TECHNICAL BULLETIN

Doc Nr: PDD2022_13 ed2
Date: 02/02/2023
Issued by: TTS - Product Support

Subject	<u>NEW Software TOUCH 5.5.0 & 5.5.2</u>
Model / PNC / Type reference	All ovens Gas & Electric (Touch screen version): <ul style="list-style-type: none"> • Electrolux Skyline Premium S (Level T), Pro S (Level K) • Zanussi Magistar Combi TS (Level T), Combi TI (Level K) • Diamond (Level T, K) • To Brand (Level T, K) • P codes (prototype ovens) • S codes (special execution ovens) • 190xxx codes
Symptom of fault	
Root cause	
Solution	
Action in Factory	New software in production
Date or s/n of introduction	5.5.0 from Wk. 50-2022 ser 2502000001 5.5.2 from WK 05-2023 ser 3052000001
Action in Field	New software is interchangeable towards all touch ovens in the market; It is recommendable to update the software and related parameters whenever visiting a site. mandatory to update the parameters file too
Spare parts

SOFTWARE UPDATE NOTES 5.5.0

Connectivity status icon

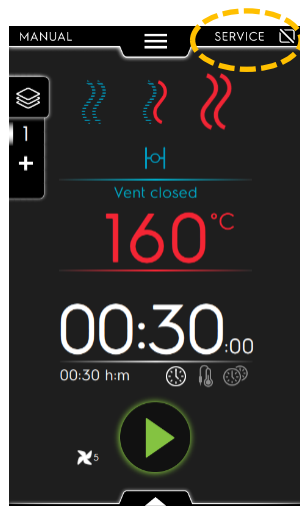
An icon is displayed for the connectivity status on the top right corner of the screen, in the top menu area, beside the username (until now only "SERVICE").

UI "Two touch" mode

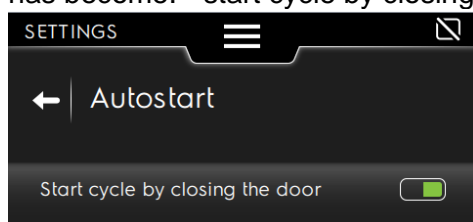
This operative mode forces the user to touch at least twice the display in different positions to execute a program. The goal of "two touch" mode interface is to satisfy regulatory requirements for gas appliances and update the "start by closing door" mode.

With this feature enabled the oven starts the cooking cycle when the door is closed and the end condition (timer value or food core temperature) of the first phase. Initially the display shows "----" avoiding the oven to start the cycle when the door is closed. This allows the user to change or update the settings of the phase, adding more phases before starting the cycle.

To start the cycle the user presses "----" the input popup is shown with the default value for the end condition. Confirming the popup, the value is set and the cycle starts.

- 1.Settings→Autostart→Switch on "Start cycle by closing door"
- 2.Parameter 459 "2tch" must be enabled, by default is set 0, "Disabled"

Update to alarms log and popups

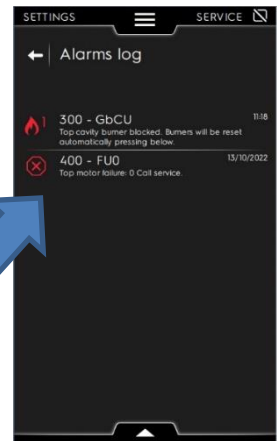
Updated the on-screen and on-file alarms log and alarm popup. The update consisted of:

- Log even the alarm reset event
- Log the gas burner blocked events
- Added to datamonitor info of the alarm triggering instant to the alarm log
- Added the possibility to display the technical ID with an icon in the alarm popup
- Display both alarm ID and mnemonic

EXAMPLE: Introduced with software 5.5 onwards, the gas burner blockings will also be stored in Alarms log.

Lambda recovery mode

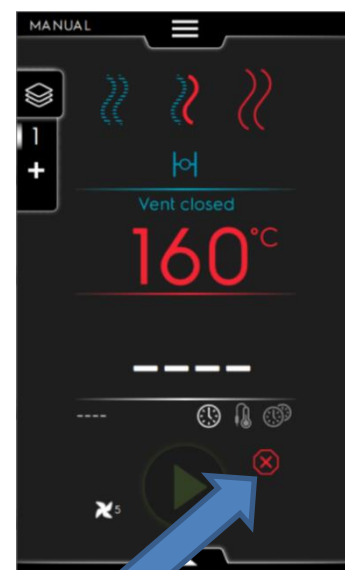
The parameter 456 LSEn (set default as **normal** ; 0, "Normal" / 1, "Advanced" / 2, "Hidden") determines the mode used to alert the user that the lambda probe is broken can be:

-“**normal**” mode, the ongoing cycle is blocked and the alarm is notified with a pop up in the standard way.

-“**advanced**” and “**hidden**” mode, the ongoing cycle is not blocked and the recovery mode is activated instantly. Furthermore, no alarm popup is displayed.

In the “**advanced**” mode the *ALARM ICON* is displayed and clicking on it the user can view the alarm popup.

In “**hidden**” mode the alarm is not notified to the user in any way during the cycle.
